IR Receiver

REV: 1.0

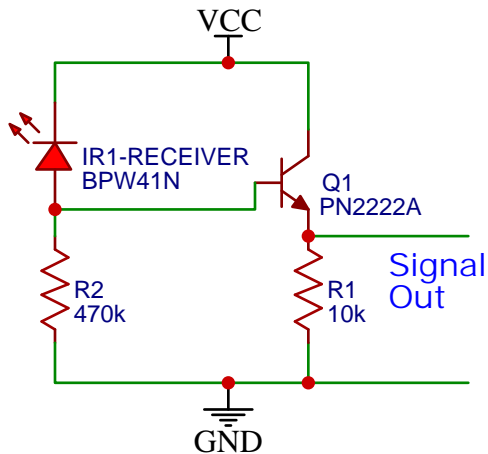
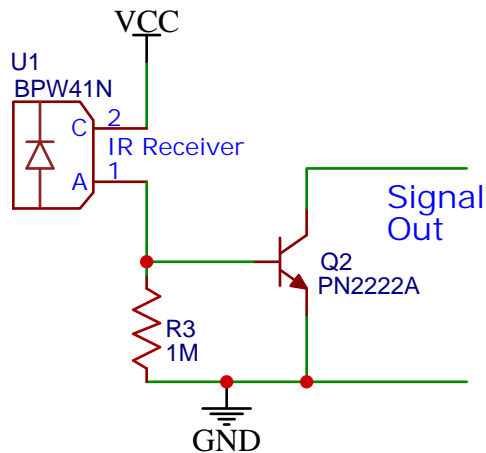
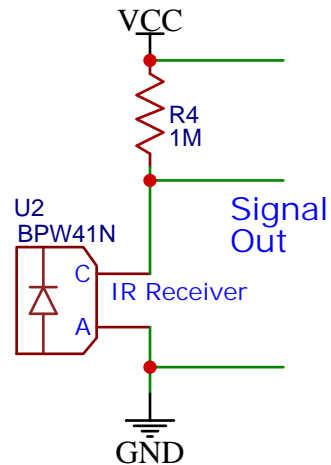
May have R1 = 220k
Emitter - Ground
instead of 10k

Revised for use with
internal pull-up
resistor.

R3 = 1M for use in dark
but 470k seems better
in daylight!!

Revised - Floating
(NO internal
pull-up resistor)
